RE: Lycee Francais Renovation
1601 Leonidas Street
New Orleans, LA 70118
Proposal # 049-3

Cost Proposal Request

Proposal Request

Architect's Project Number: **15101**
Proposal Request Number: 04

01 FIRST FLOOR PLAN
1/8" = 1'-0"

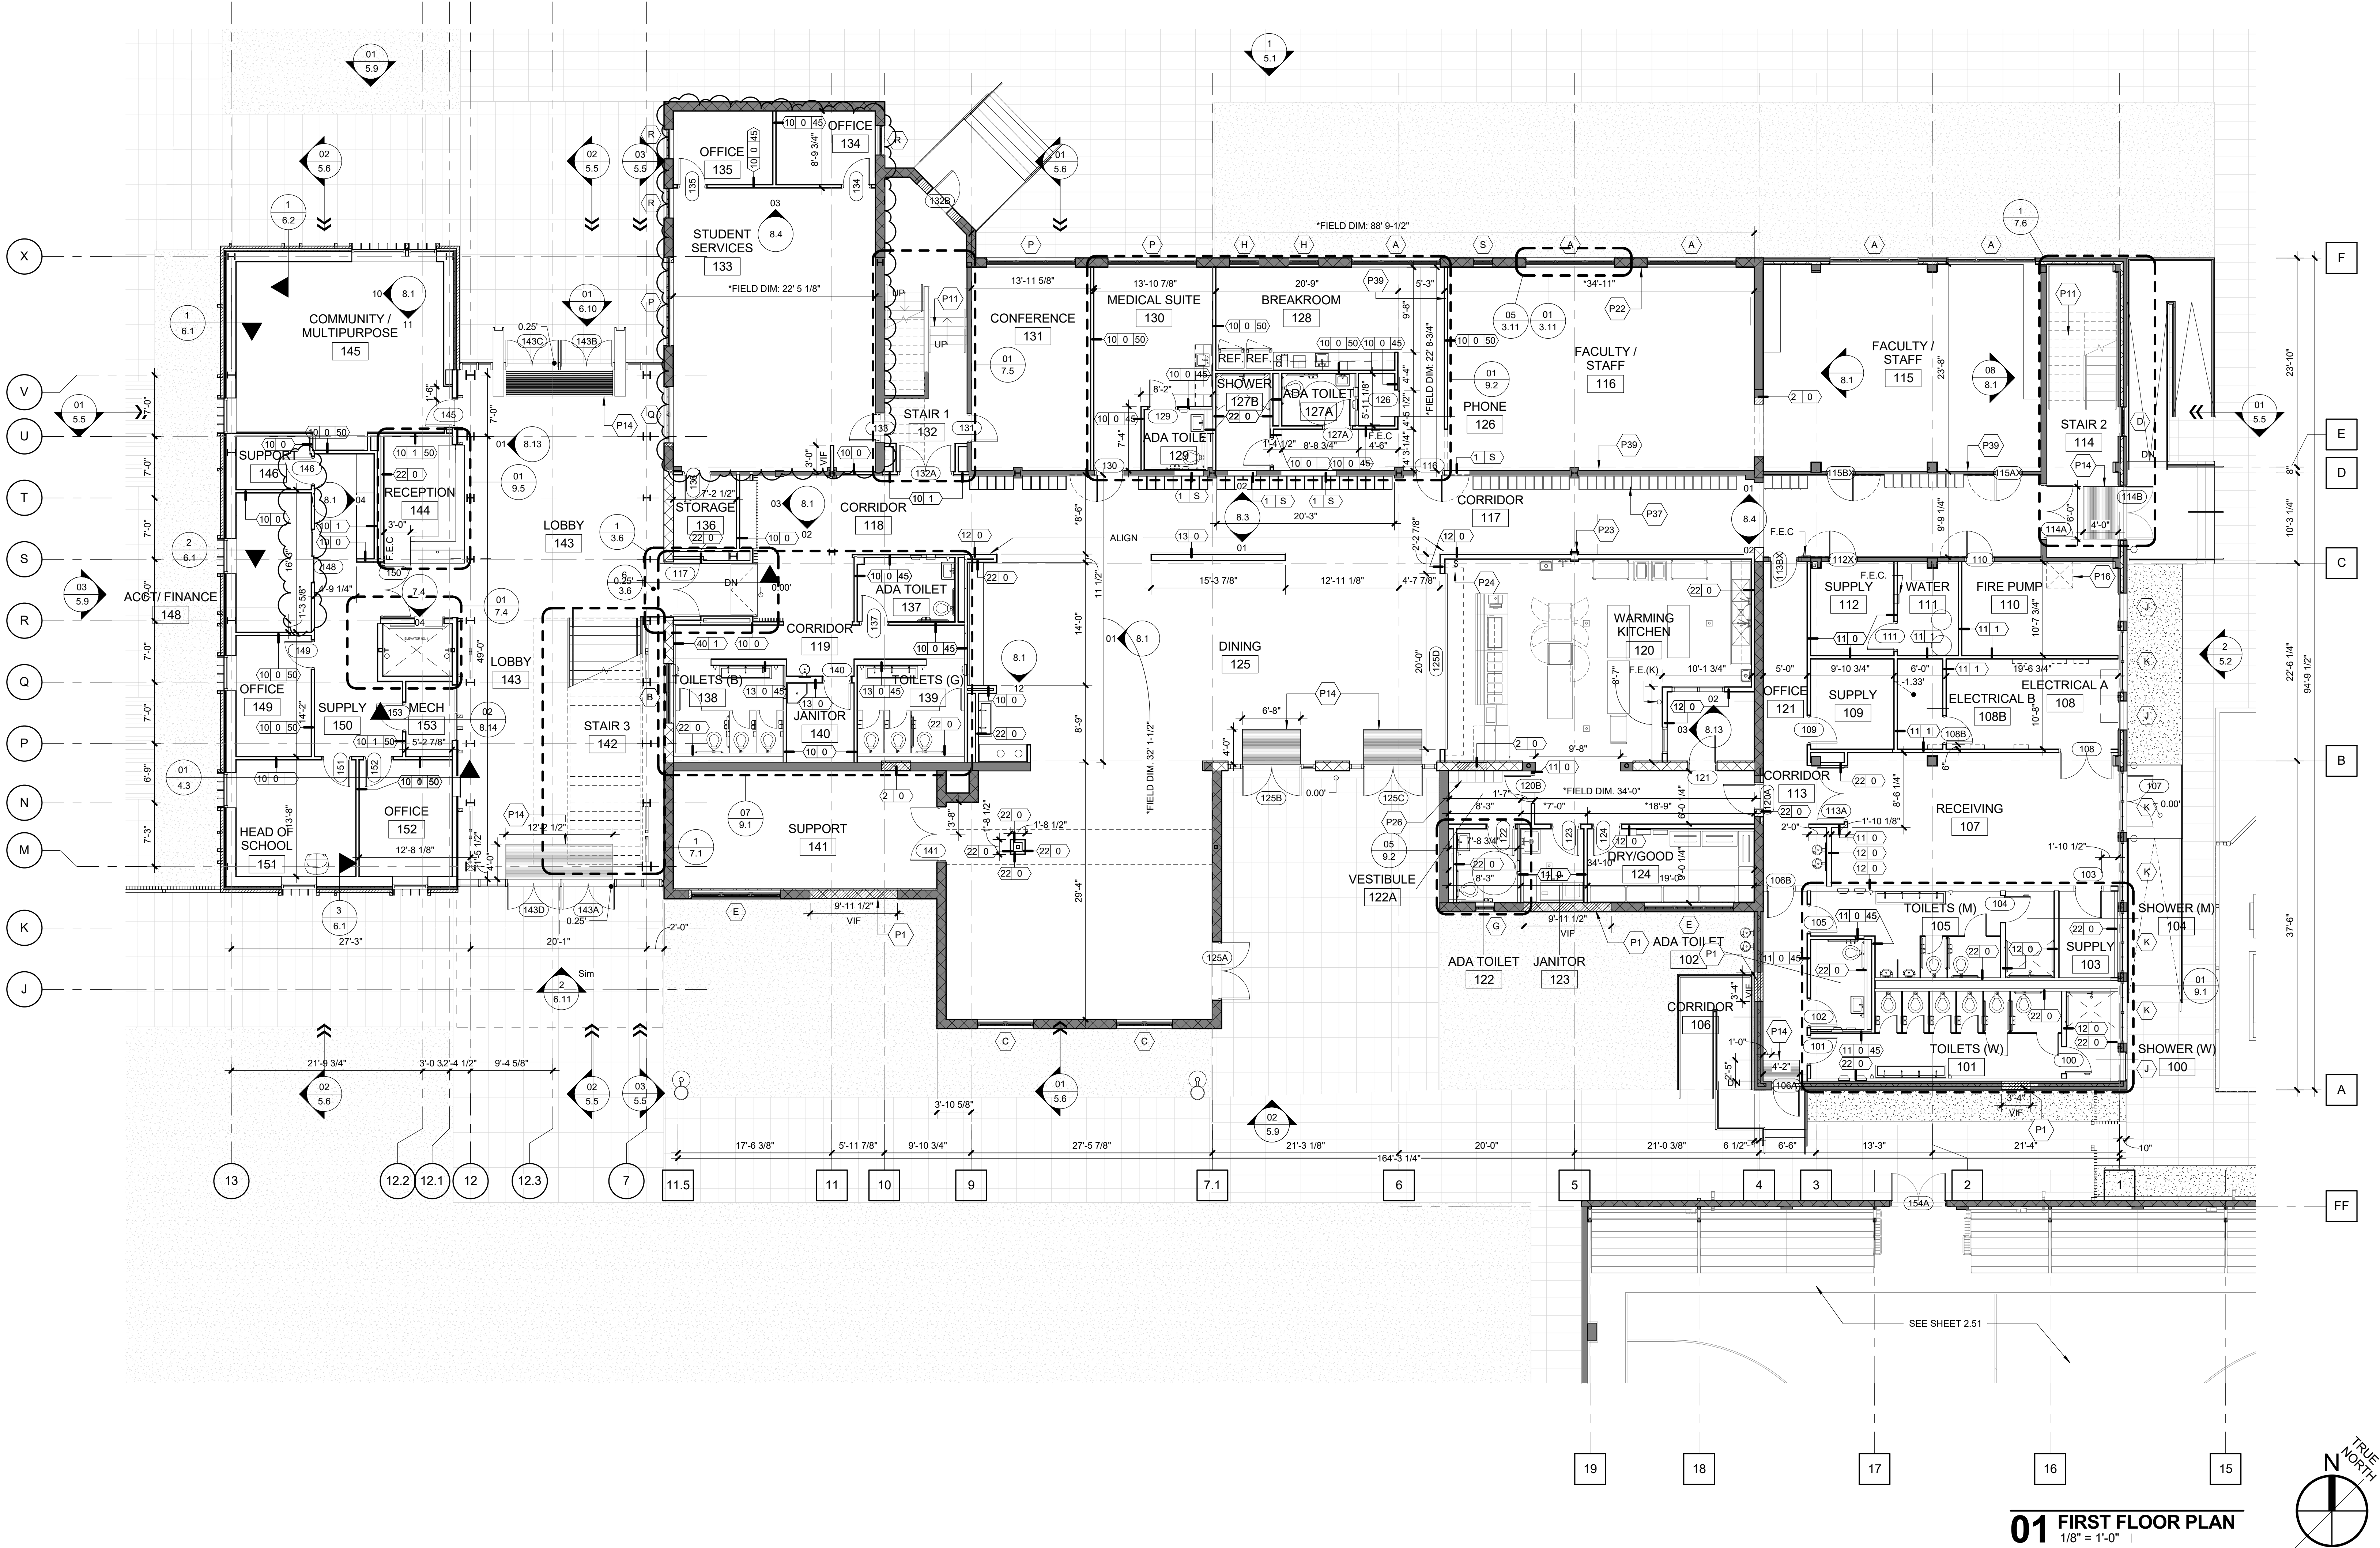
Acct/Finance 148: Changed dimension of the room and added a glass slider door (see cut sheet attached, door added to door schedule). Adjusted MEP accordingly. Provide price for changes to this room separately from the other work: \$ _____

Student Services 133 and Offices 134/135: Moved the two offices to the other end of the room. Adjusted ceiling plan and MEP accordingly. Provide price for changes to this area separately from the other work: \$ _____

FIRST FLOOR PLAN

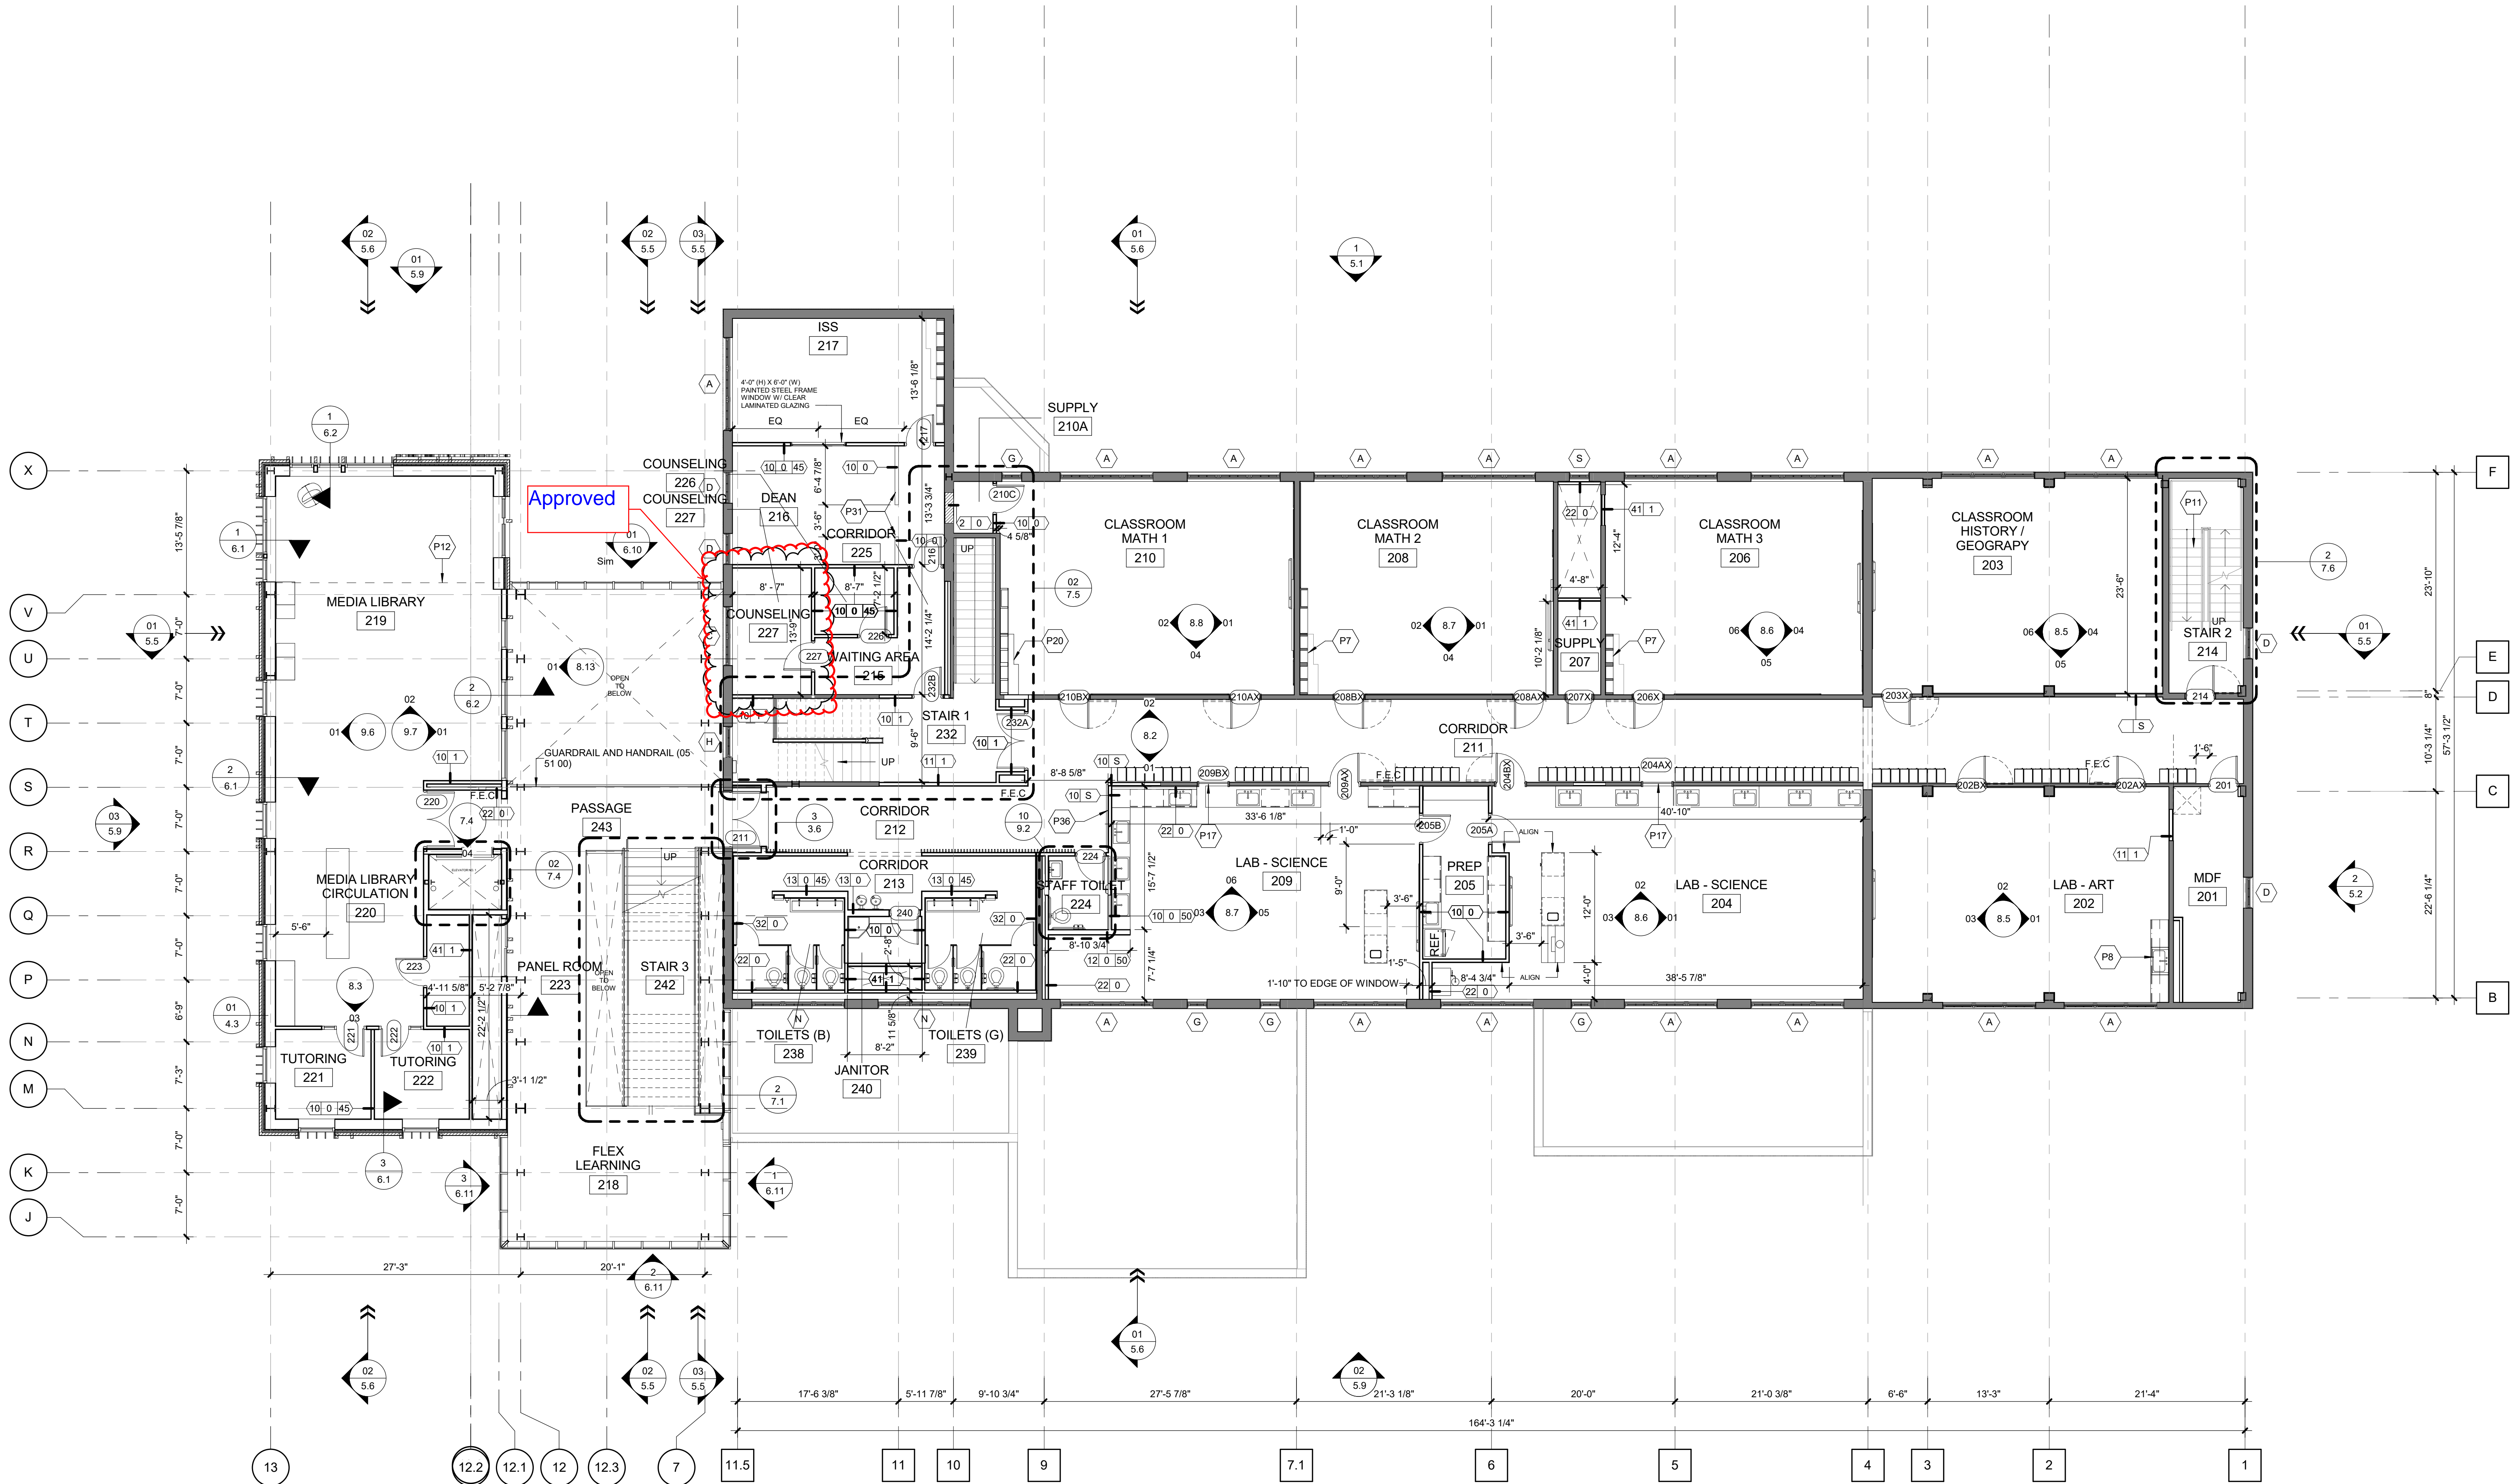
Counseling 227: Adjusted layout of room. Adjusted ceiling plan and MEP accordingly. Provide price for changes to this room separately from the other work: \$ _____
